TITLE KMS156 CABLE JL-2H RF-ø1.37

A4 | DWG NO. CN03404-7/1 | REVISION 4 | SHEET 1 of 1

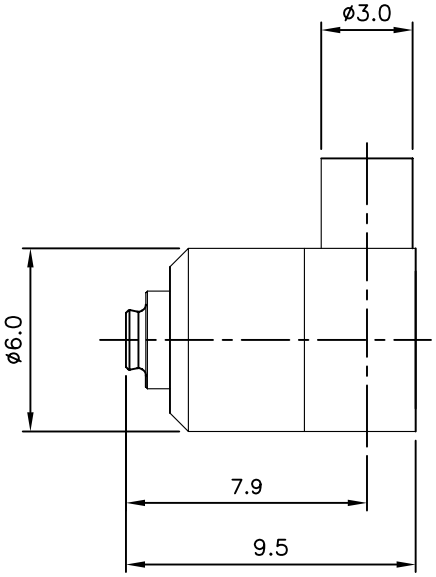
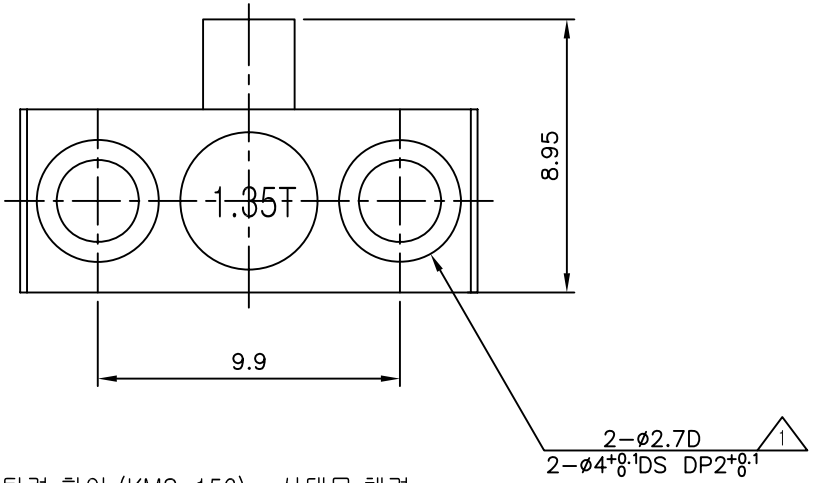
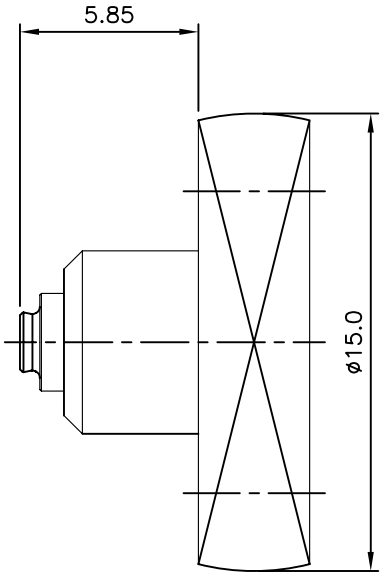
REV	DESCRIPTION	DRAWN	APPR	DATE
IR	Initial Registration	H.J.LEE	I.C.KIM	2015.03.13.
1	[설변 No.201504-0004] 홀 부분 단차형태로변경	S.M.LEE	I.C.KIM	2015.04.08.
2	[설변No.201710-0014] BODY와 절연체 조립 시 퍼짐 방지로 인한 BODY 내경치수 변경	S.Y.EUN	I.C.KIM	2017.10.25.
3	[설변No.201801-0001] 케이블 변경으로 인한 케이블 삽입부 바디 내경 수정	S.Y.EUN	I.C.KIM	2018.01.02.
4	[설변No.201805-0017] 절연체 Burr 끼임 방지로 인한 PIN 및 절연체 공차 변경	S.Y.EUN	I.C.KIM	2018.05.28.
